Access Compliance Report

Public Rights-of-Way

(Curb Ramps)

Intersection ID: 10025681	Main Street: EAST_BV	Cross Street: N/A	Location: NE
ADA ID: A50D372A5A26	Ramp Type: Perp	Initial Pass/Fail: Fail	Overall Compliance: No
		Severity Score: 37.5

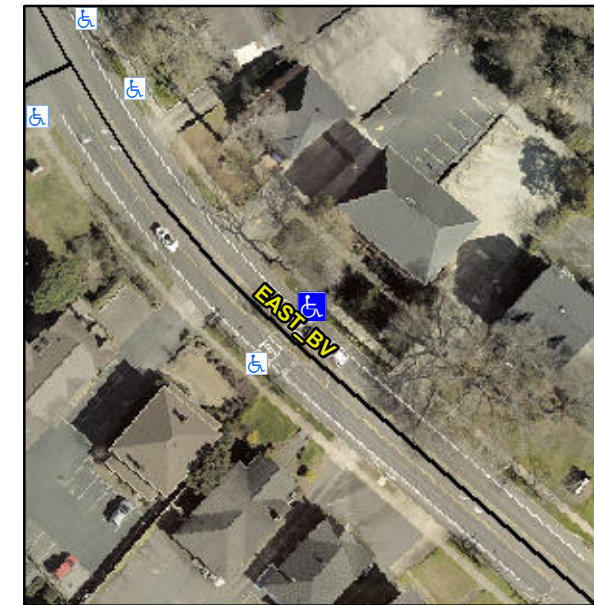
Possible Solutions:

Remove & Replace Entire Ramp.

PROW/ADA:

R304.2.2, R304.5.3

Compliance	Description	Data	Compliance	Description	Data
N/A	Ramp Length (in)	66.0	No	Ramp Slope (%)	17.9
Yes	Ramp Width (in)	74.0	No	Ramp XSlope (%)	6.3
N/A	Flare Type LT	N/A	N/A	Flare Type RT	N/A
N/A	Flare Slope LT (%)	N/A	N/A	Flare Slope RT (%)	N/A
N/A	Flare Traversable LT?	N/A	N/A	Flare Traversable RT?	N/A
N/A	Landing Length (in)	N/A	N/A	DWS Provided?	N/A
N/A	Landing Width (in)	N/A	N/A	DWS Contrast?	N/A
N/A	Landing Slope (%)	N/A	N/A	DWS Length (in)	N/A
N/A	Landing X Slope (%)	N/A	N/A	DWS Full Width?	N/A
N/A	Landing Curb? (Y/N)	N/A	N/A	DWS Offset (in)	N/A
N/A	Shared Landing?	N/A			
N/A	Gutter Ponding?	N/A	N/A	Gutter Slope (%)	N/A
N/A	Gutter Lip Ht (in)	N/A	N/A	Gutter X Slope (%)	N/A
N/A	Painted X Walk1?	Yes	N/A	Painted X Walk2?	N/A
	X Walk 1 Direction	To SW		X Walk 2 Direction	N/A
N/A	X Walk 1 Width (in)	97.0	N/A	X Walk 2 Width (in)	N/A
	X Walk 1 Slope (%)	3.7		X Walk 2 Slope (%)	N/A
	X Walk 1 X Slope (%)	4.0		X Walk 2 X Slope (%)	N/A
